**BEFORE THE PUBLIC UTILITY COMMISSION
OF OREGON**

LC 85

2025 Integrated Resource Plan and Clean
Energy Plan.

ORDER

Figure 1: Existing Load & Resource Position by Jurisdiction. Docket No. LC 85; [PacifiCorp's Round 2 Reply Comments](#), November 6, 2025, Figure F.

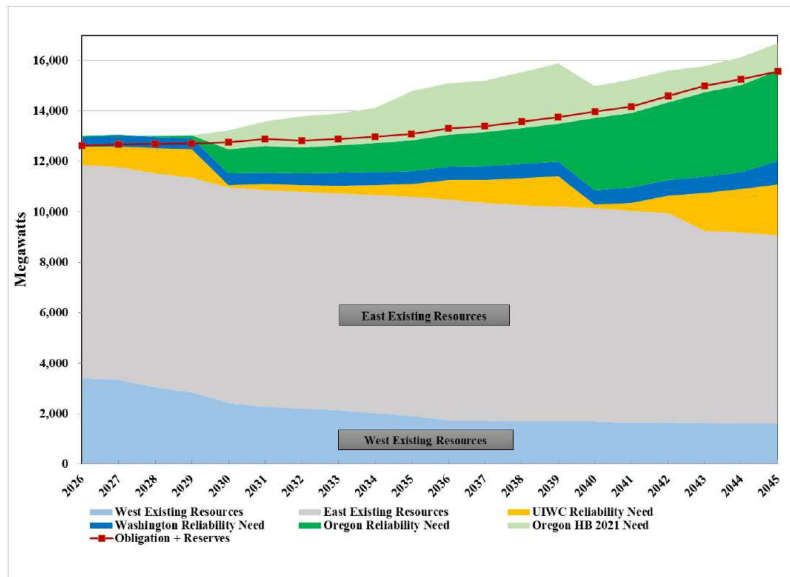
Overbuilding concerns are emphasized by the following graph, which was included in the Company's Round 2 comments. While Staff disagrees with the jurisdictional assignments (e.g. the reliability need is not Oregon-specific), Figure 1 shows that generation resources attributed to HB 2021 are by large unnecessary from a resource

adequacy perspective. This implies that it should be possible to reduce costs somewhat by changing the allocation of existing resources or energy, instead of building or acquiring new resources.
